PCO #098 WT-3 Clerestory Remediation

WCC PCO #098 - WT-03 Clerestory Remediation - Change Order Narrative

CUNY New Academic Building

1130 - Design Movement between the Auditorium and Main Building

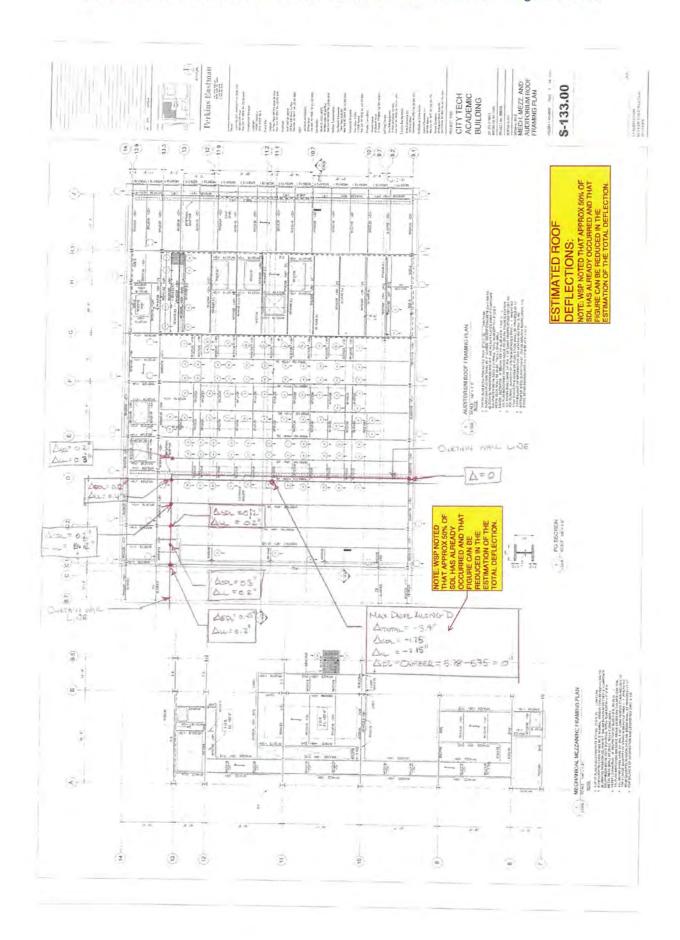
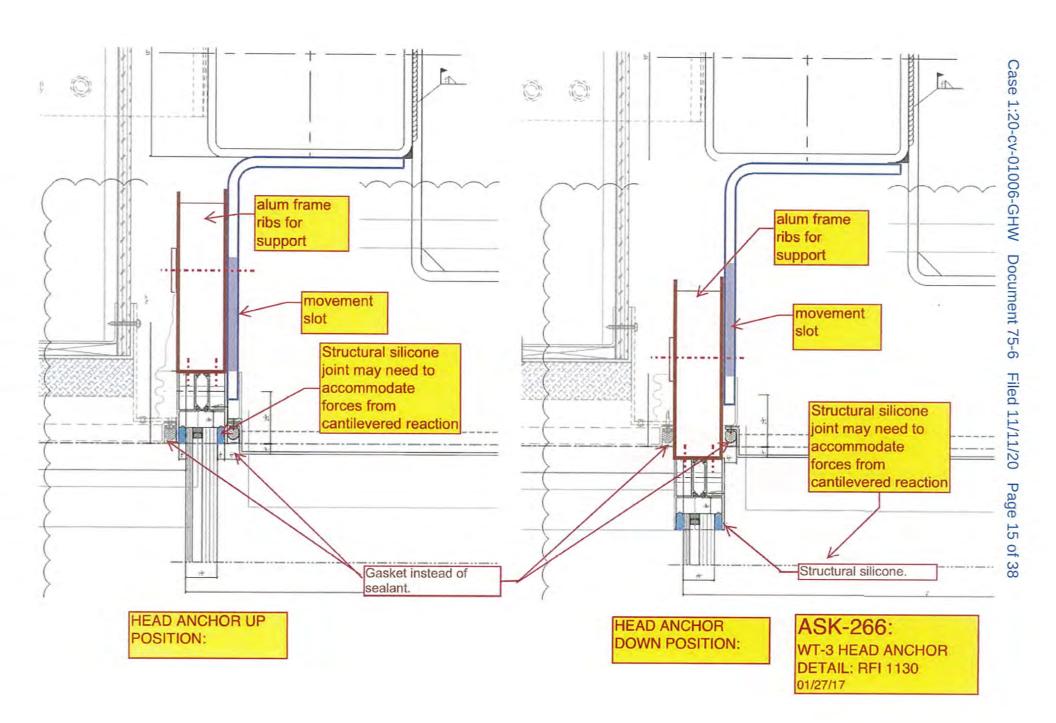
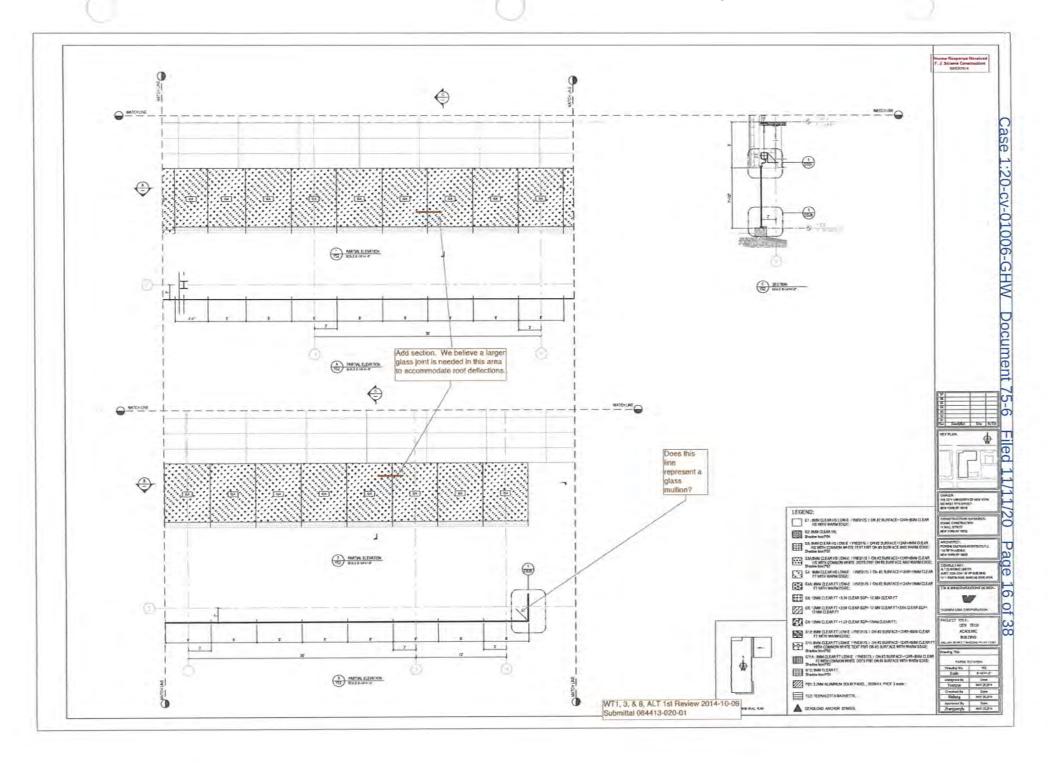
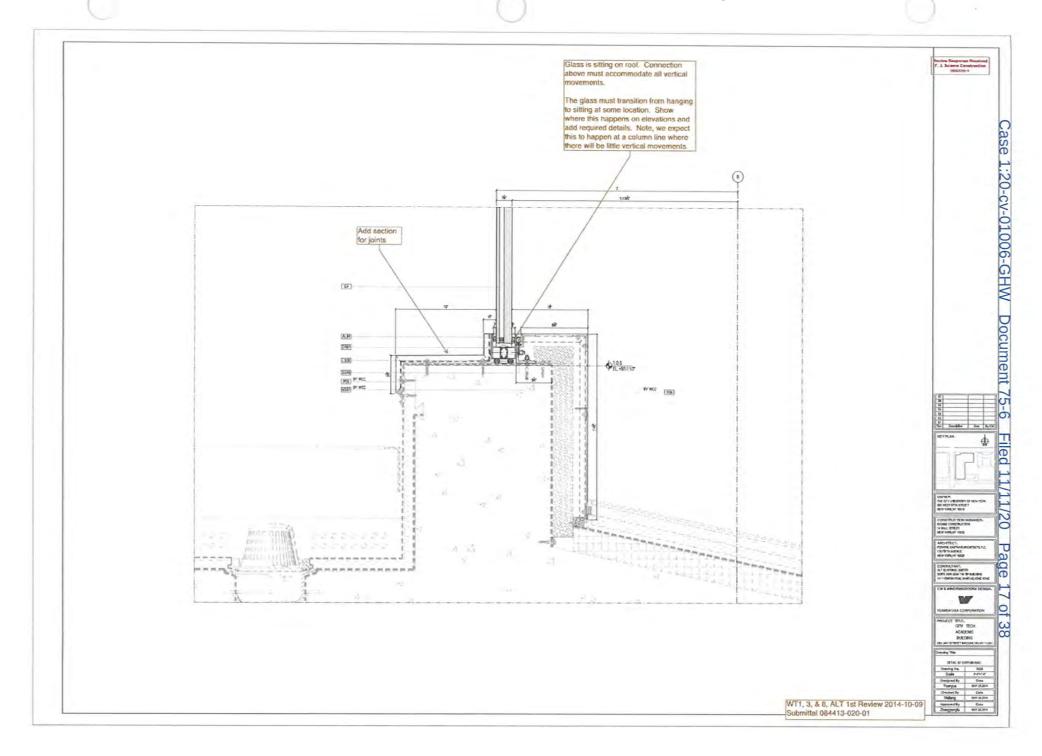
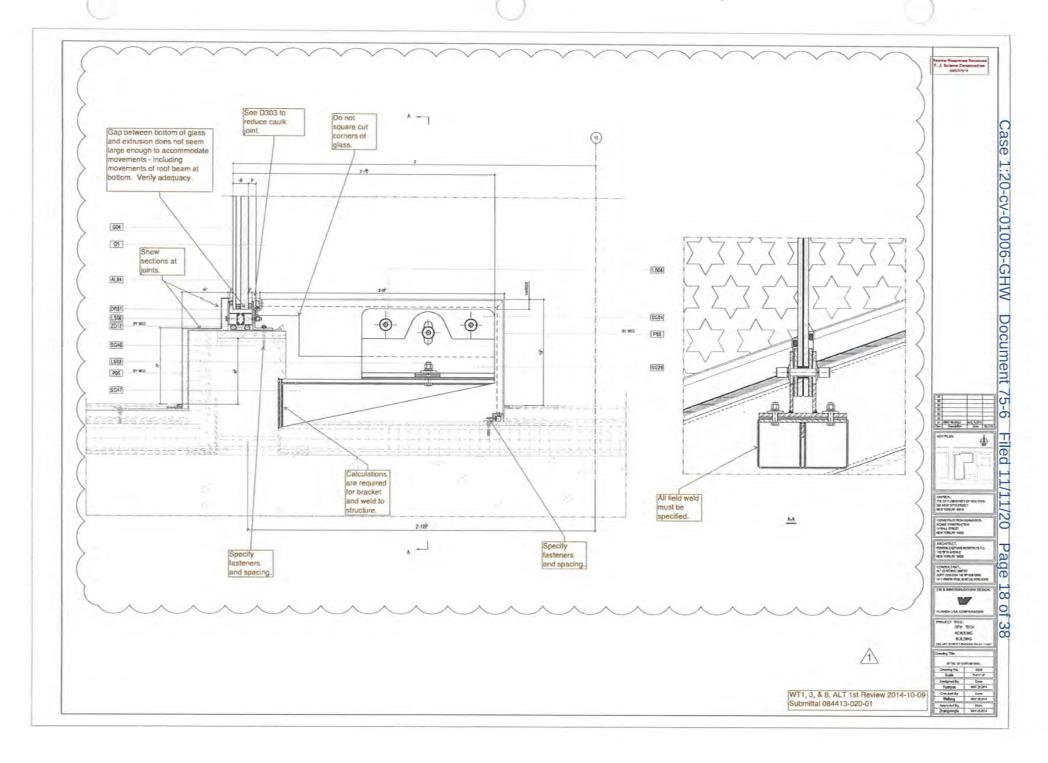
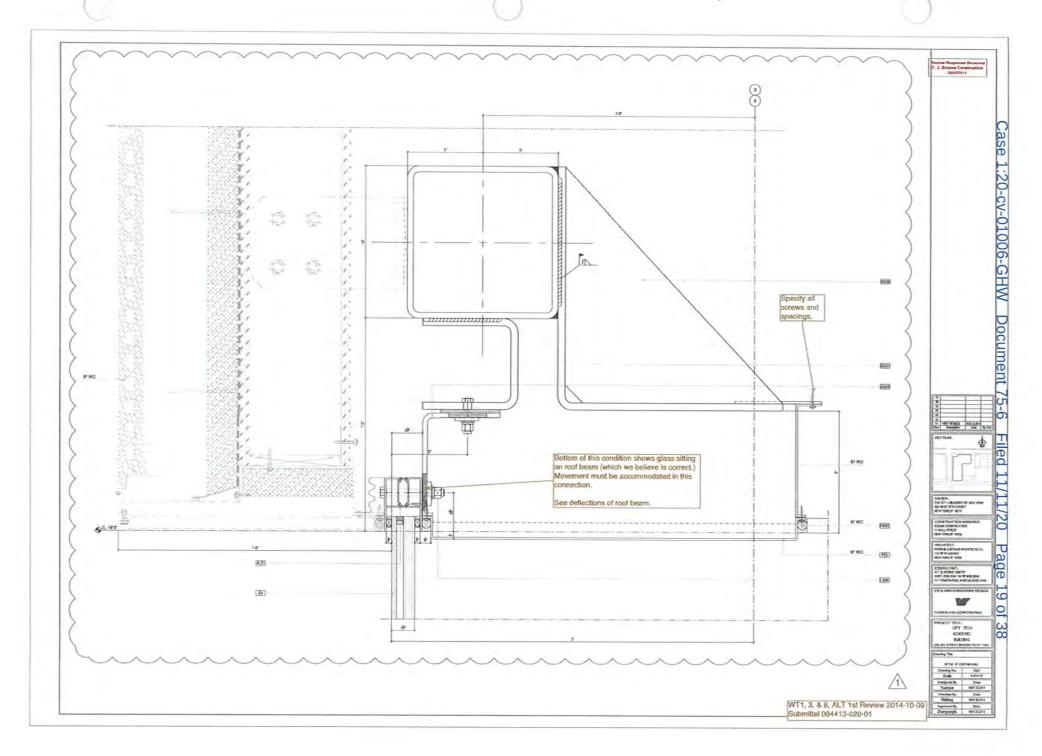
In reviewing submittal 084426-007-01 the Design Team included a comment that "The structural adequacy of this anchor and the relative movements between auditorium roof and main building still has not been submitted." Please define what the relative movement between the auditorium roof and main building is per design so that Whitestone can provide Yuanda with that information for analysis to ensure that the design movement was adequately addressed in the facade design.

SHOP DWG SUBMISSION NUMBERS MUST BE IN SEQUENCE OF THE PREVIOUS SUBMISSIONS. 2. THE CONCERN WAS PREVIOUSLY NOTED IN 2014 UNDER

FROM SUBMITTALS 084413-020-01 AND 084413-020-02 ON SHEETS D328, D329, D331 AND Y52 TO VERIFY A LARGER MOVEMENT JOINT TO

ACCOMODATE ROOF DEFLECTIONS. THE NOTE WAS ALSO INDICATED

ON RFIS 1033 AND 1033R1. Dan Dillon

REFER TO ATTACHED ESTIMATED ROOF DEFLECTIONS BY WSP. NOTE: WSP CLARIFIED 50% OF THE SDL HAS ALREADY OCCURRED AND THAT FIGURE CAN BE REDUCED. EVEN WITH THE 50% REDUCTION OF THE SDL DEFLECTION, WE BELIEVE THE CONTRACTOR'S HEAD

NAME ANCHOR DETAIL MAY NOT ACCOMODATE THE ESTIMATED ROOF DEFLECTIONS. Dan Grimaldi

4. REFER TO ASK- 266 FOR SUGGESTION FOR THE HEAD ANCHOR DETAIL TO ACCOMODATE POTENTIAL MOVEMENT.

SUBMITTAL: Drawings 084413-020-02, Calcs 084413-020.001-02

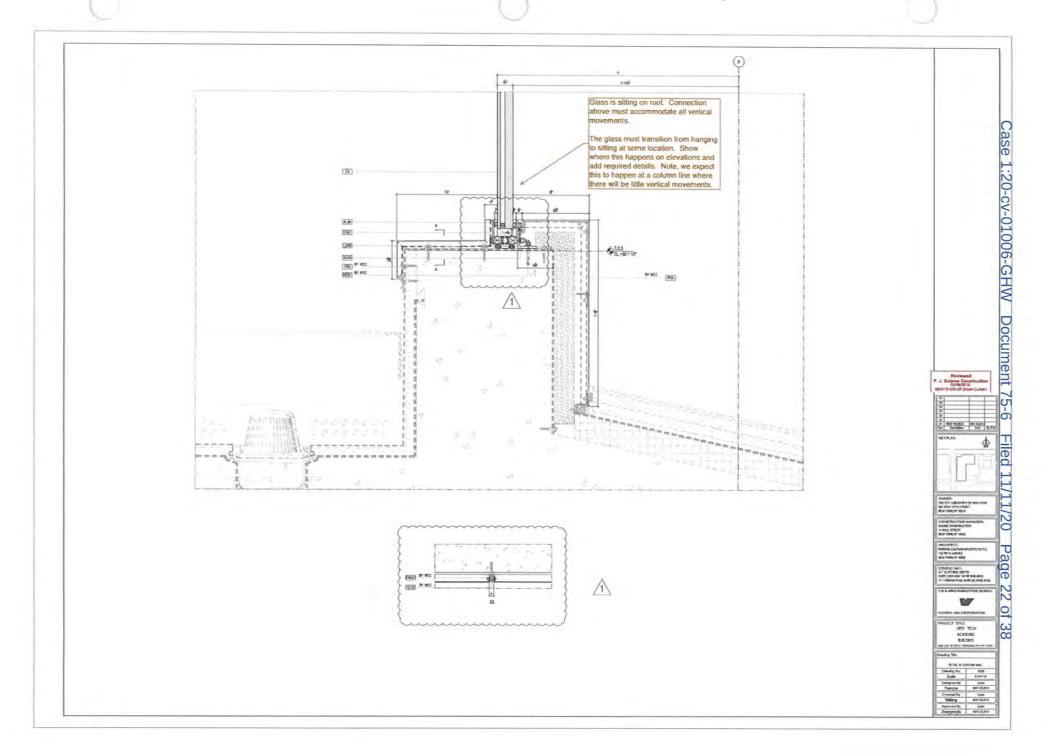
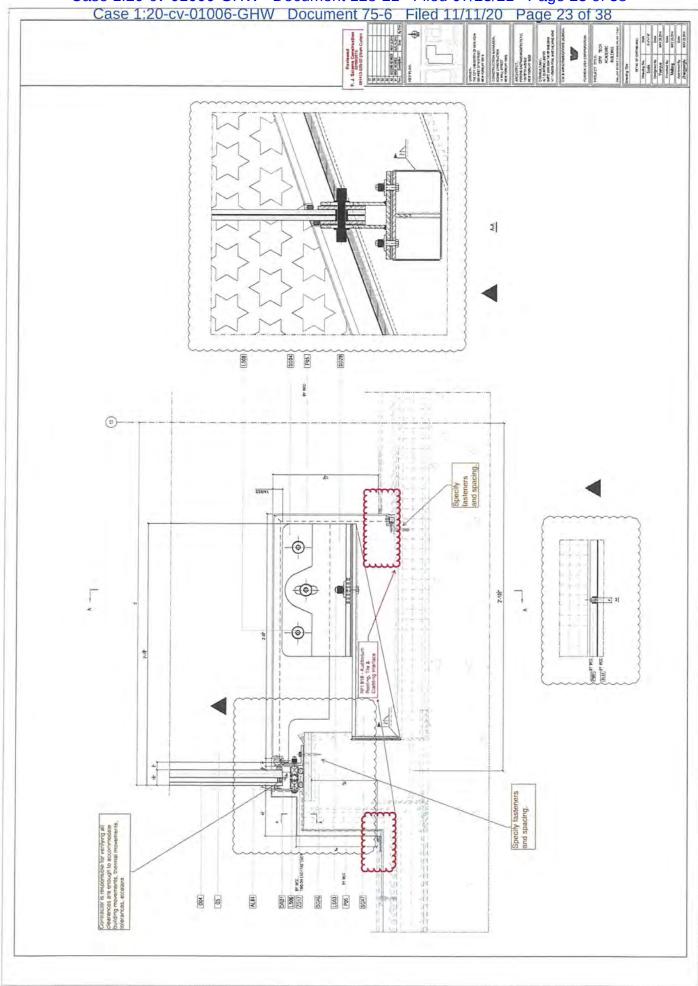
- 1- SEE ENLOSED COMMENTS FROM ALT AND PE.
- 2- THE SPLICE SEAL AND CORNER MULLION CALCS AND CORNER CONDITION MUST BE ADDRESSED.
- 2- PREVIOUS SUBMITTAL COMMENTS MUST BE ADDRESSED.
 3-CM TO COORDINATE WITH ALL APPROVED DECKING,
 APPROVED SLAB EDGE, T.O.S. ELEVATIONS, GRADE
 ELEVATIONS AND APPROVED FRAMING PLANS; TYP.

- 4- COORDINATE WITH APPROVED ADJACENT WALL ASSEMBLIES AND TRANSITIONS; TYP.
- 5- PROVIDE ACTUAL PROJECT CONDITION DETAILS AT THE VARIOUS WALL TRANSITIONS. MATERIAL SPECS AND TRANSTION DETAILS MUST BE PROVIDED FOR ELEMENTS BY WCC.

- 6- REFER TO COMMENTS ON STRUCTURAL CALCULATIONS, INLCUDING PROVIDING STRUCTURAL CALCULATIONS FOR THE WCC ELEMENTS INCLUDING HORIZONTAL TUBE AND ANCHORAGE LOCATIONS.

- SPECIFY FILLER METAL FOR ALL STAINLESS STEEL WELDS.
 VERIFY FILLER METAL FOR WELDS MEETS FILLER METAL ASSUMED IN CALCS.

Splice seal. I think they need to fix the non-moving portions of the reinforcing extrusion so
that the joint that is intended to move will, in fact, be the joint that moves.

1 cannot tell if the corner mullion calcs are correct. I would expect to see the mullions rotated 45 degrees in the computer runs to model the principle axis of the mullions, but this is not there.
